PRODUCT CHANGE NOTICE

Data Sheet Specification Change for Intersil Product ISL55015IEZ-T7

**Refer to:
PCN13015**

Date: February 19, 2013

Small Outline Transistor Plastic Packages (SC70-6)

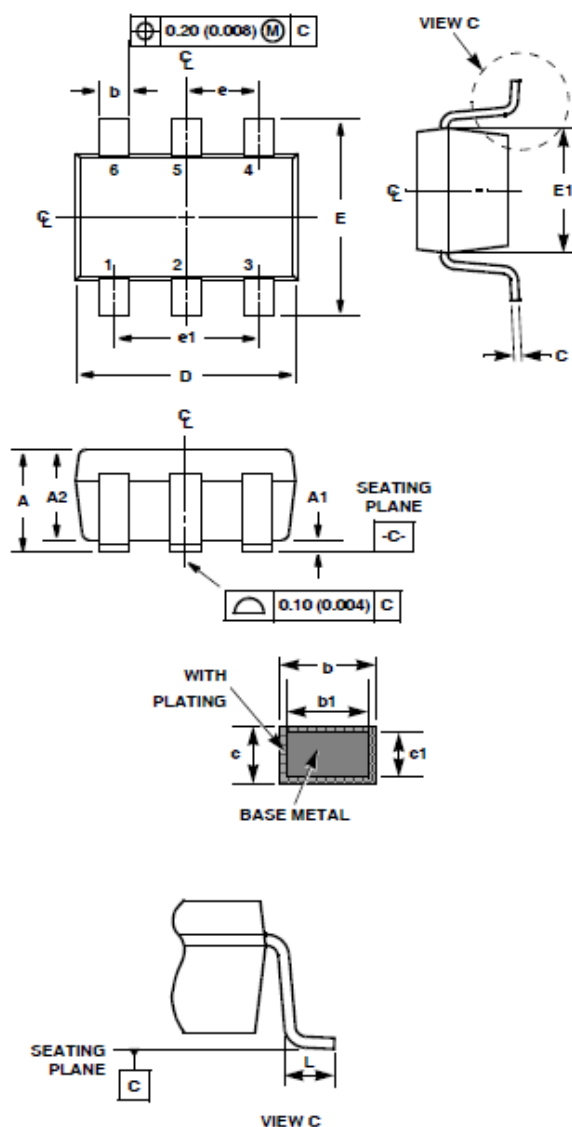
- Corrected the ESD level for Machine Model in the *Absolute Maximum Ratings* section.
- Updated Theta JA and added Theta JC in the *Thermal Information* section.
- Output Power at 1dB Compression (P1dB) parameter limits changed in the *Electrical Specifications* table.
- Replaced the *Package Outline Drawing (POD)* to align with product change notice PCN12091.

P6.049B
